Subject: AP1000 COL Standard Technical Report Submittal of APP-GW-GLN-019, Revision 1
(TR 103)

1. APP-GW-GLN-019, Revision 1, "Fluid System Changes," Technical Report Number 103

WESTINGHOUSE ELECTRIC COMPANY
AP1000 Licensing Design Change Document

Title: Fluid System Changes

Figure 9.2.7-1 (Sheet 2 of 3)

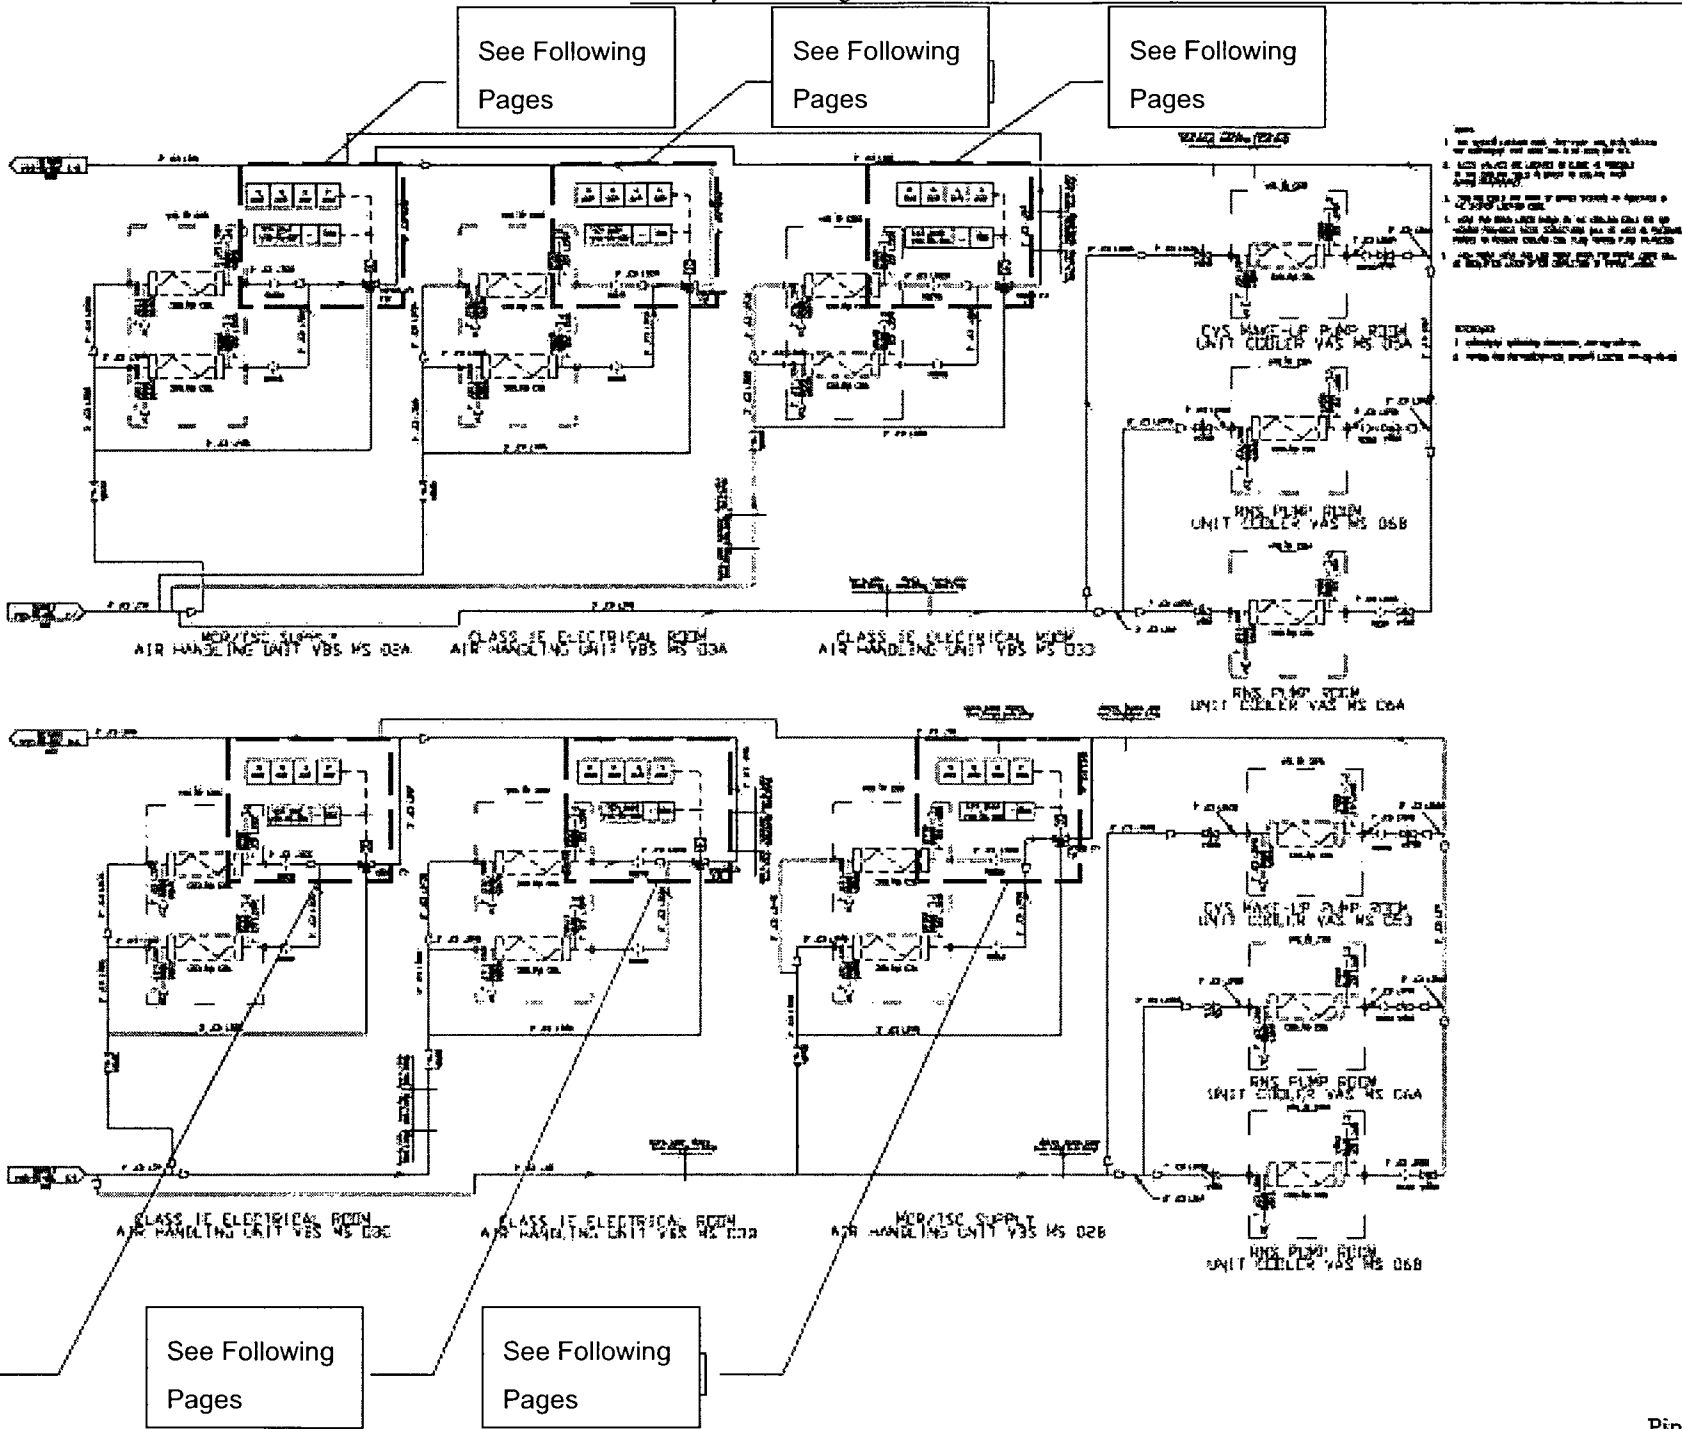
To provide the necessary design flexibility, the integral instrumentation is replaced with standard in-line instruments within the identified figures of the DCD or removed, and references to valves with internal instrumentation be removed from the DCD text. This replacement does not change the functional or design of any valves or instruments.

The diagrams in question are Figure 9.2.1-1 (Service Water System – APP-SWS-PL-V011 and –V009) and Figure 9.2.7-1 Sheet 2 of 3 (Central Chilled Water System – APP-VWS-PL-V272A/B, and -V261A/B/C/D)

Figure 9.3.6-1 (Sheet 1 of 2)

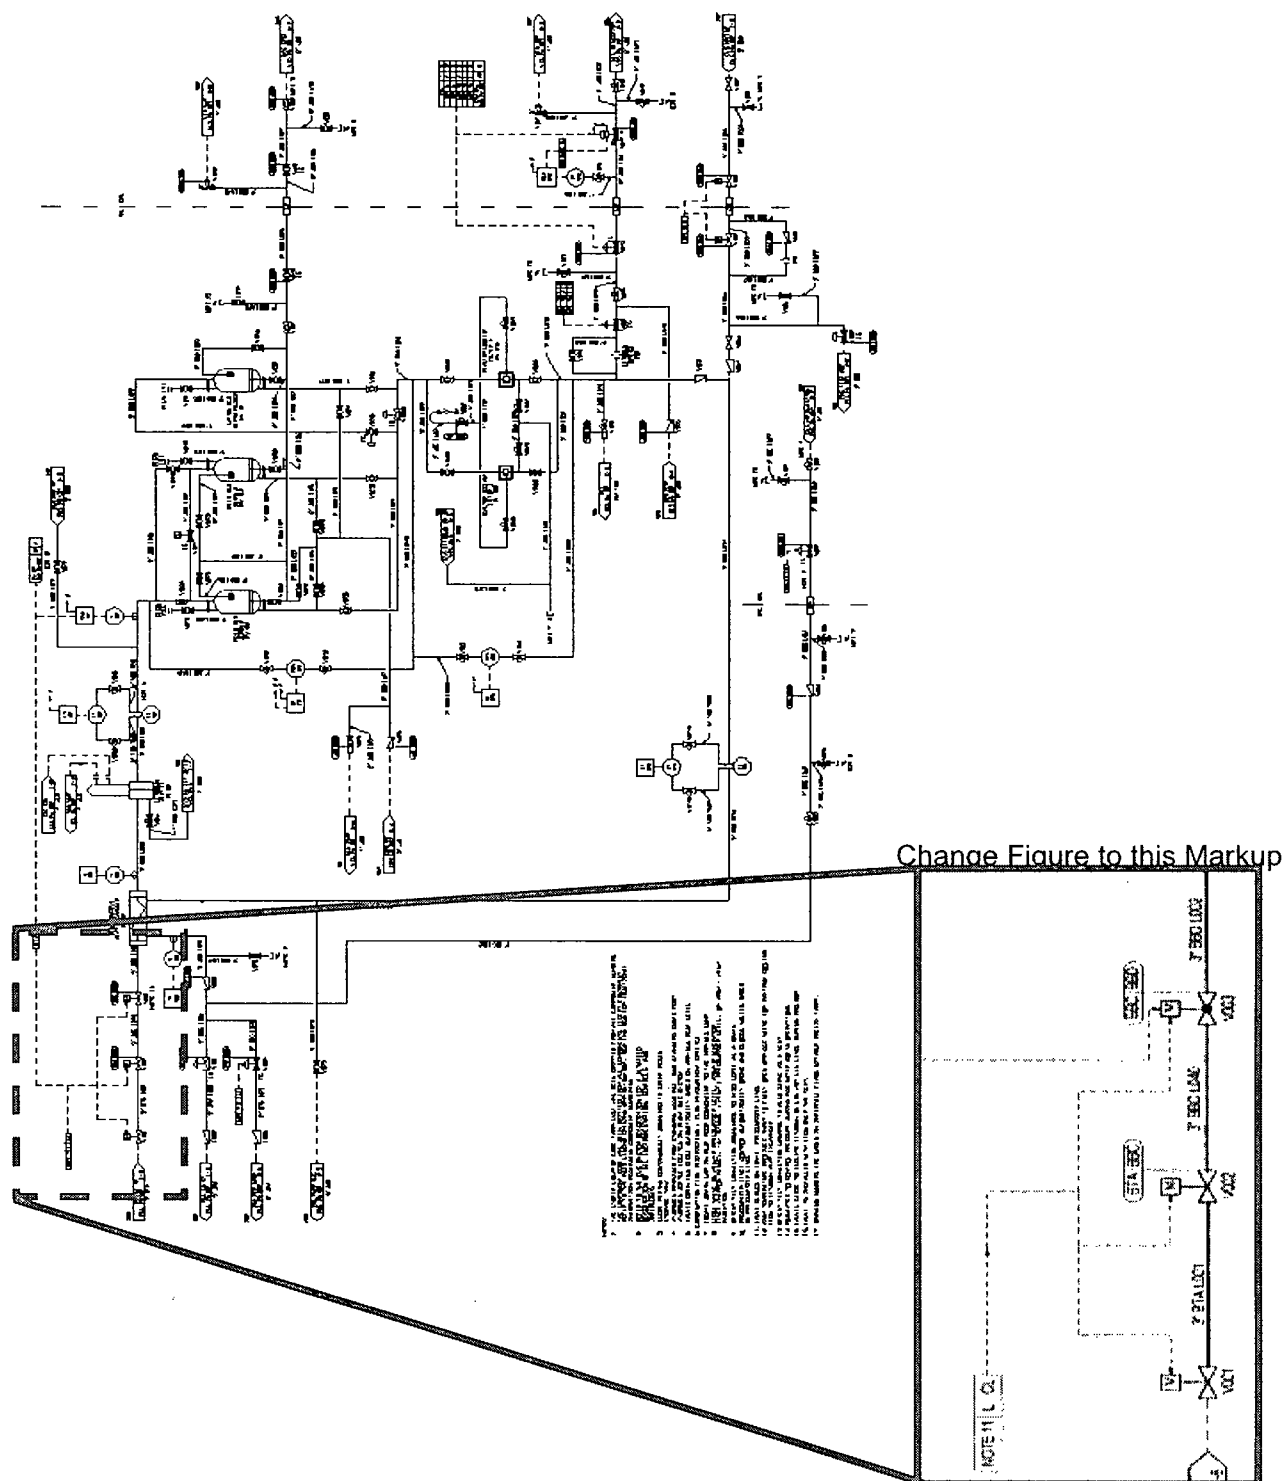
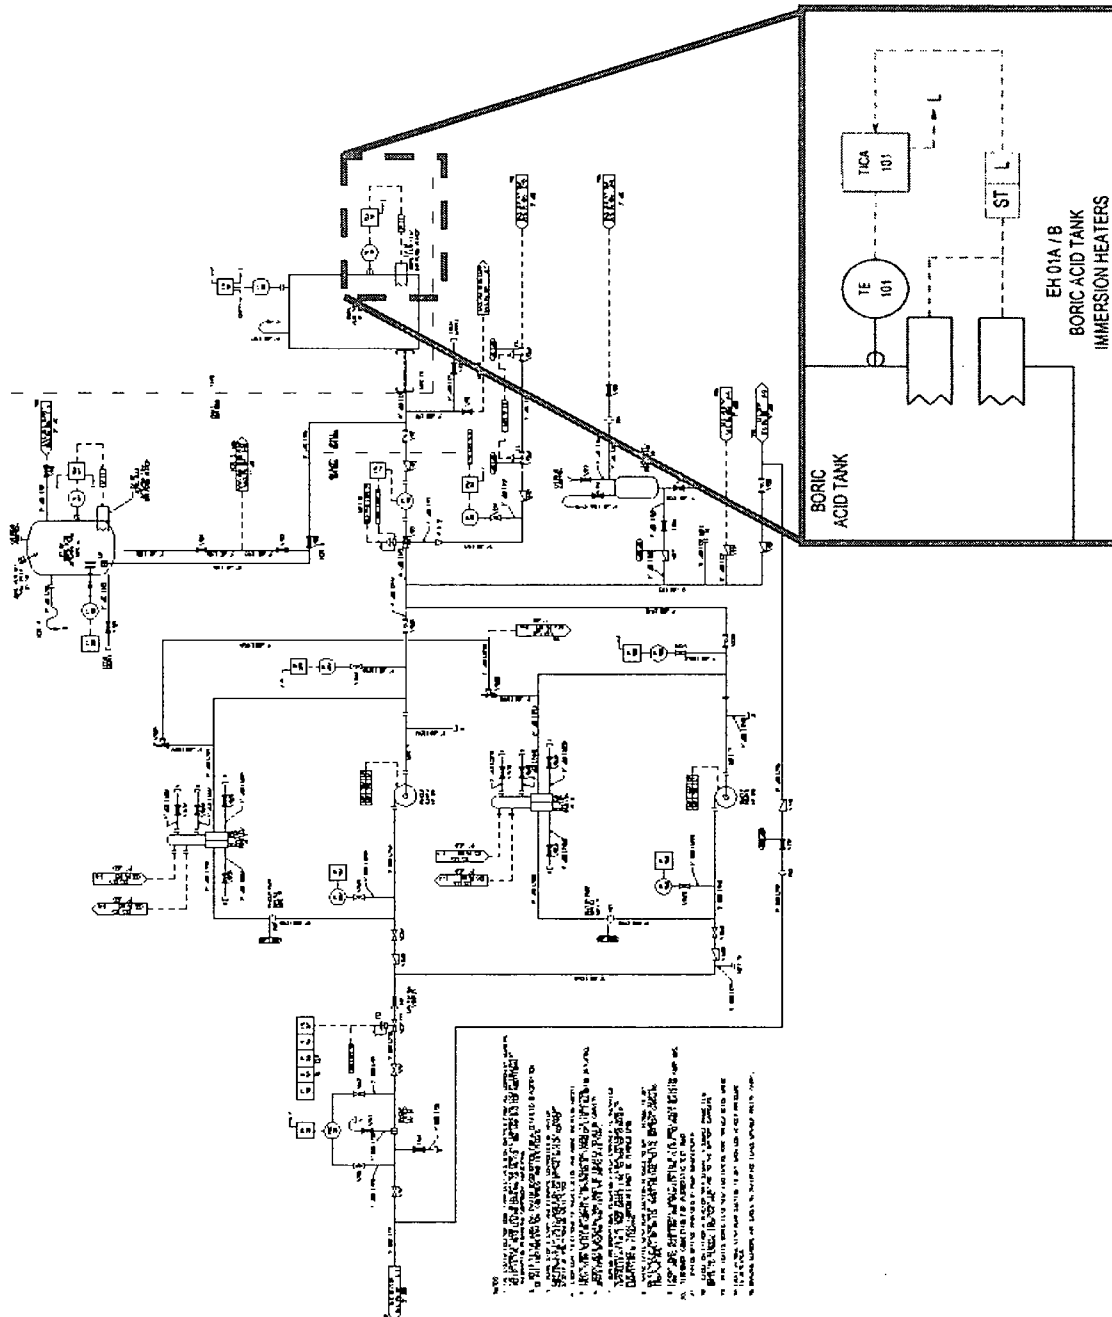
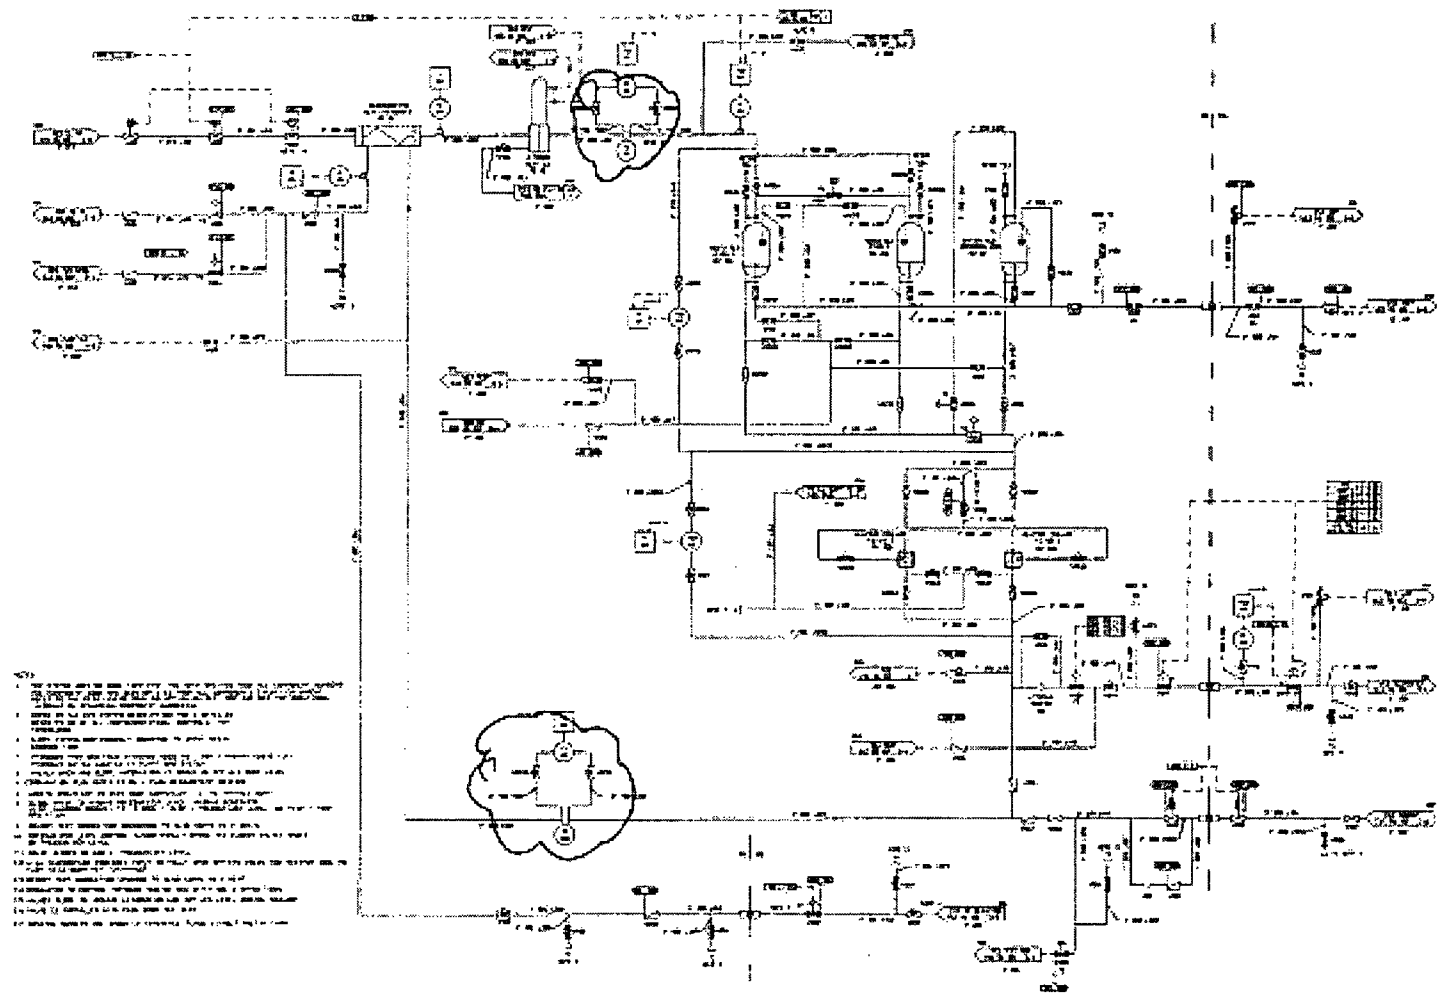
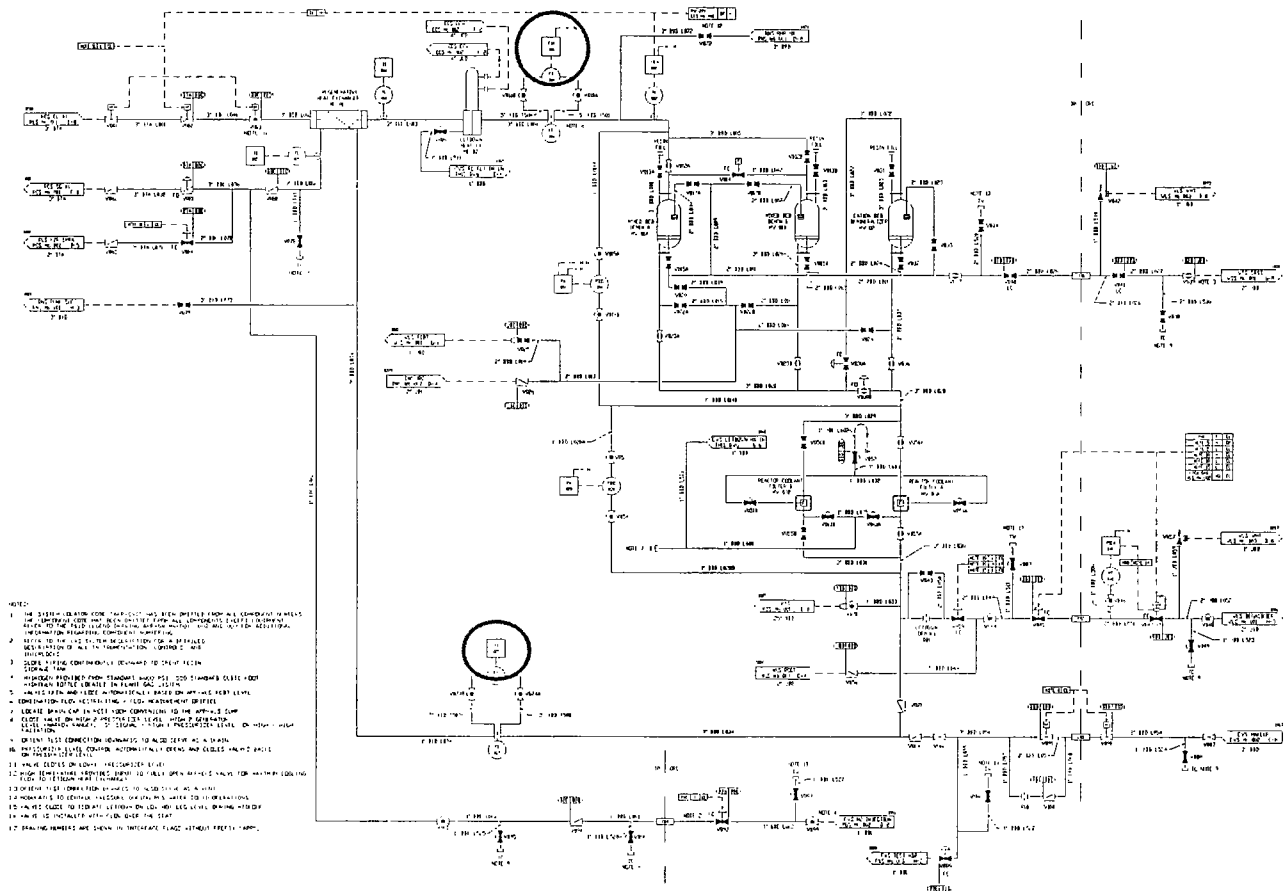
A single MOV closure is sufficient for automatic CVS isolation, and therefore, the interlocks between TICA-002 and CVS-PL-V001 and V002 are deleted as marked on the schematic drawing.

Revised DCD Figure 10.4.7-1 (Sheet 4 of 4)
Startup Feedwater P&ID Changes

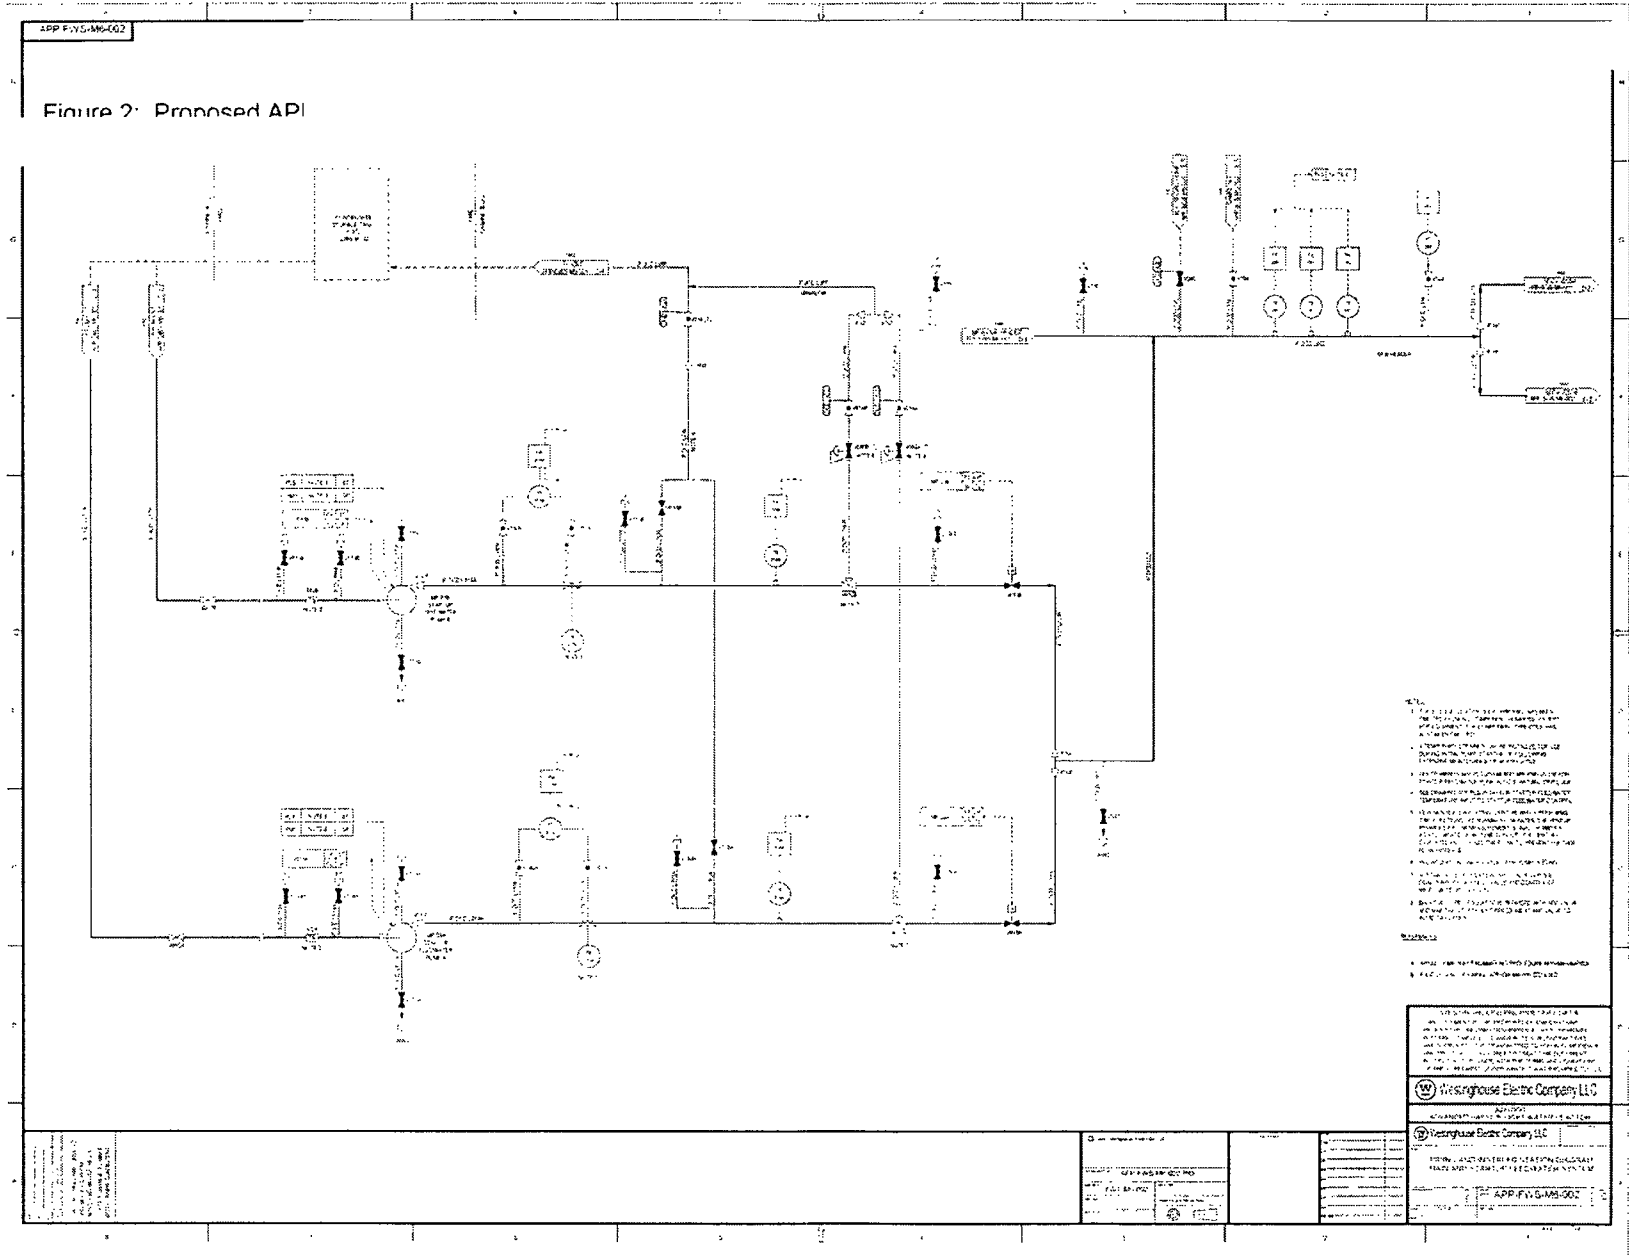
The current Startup Feedwater P&ID (AP600 Rev 5) does not reflect the AP1000 startup feedwater control system. It is necessary to eliminate the control function shown on DCD Figure 10.4.7-1 (Sheet 4 of 4), and in DCD section 7.7.1.8.2 for pressure transmitters PT 043-45 because the startup feedwater header pressure is no longer an input to the Startup Feedwater control System. Additionally, the Main Feedwater System also no longer utilizes the main feedwater header pressure or pressure drop across the main feedwater control valve as an input to its control system. Therefore, section 7.7.1.8.1 of the DCD has been revised.
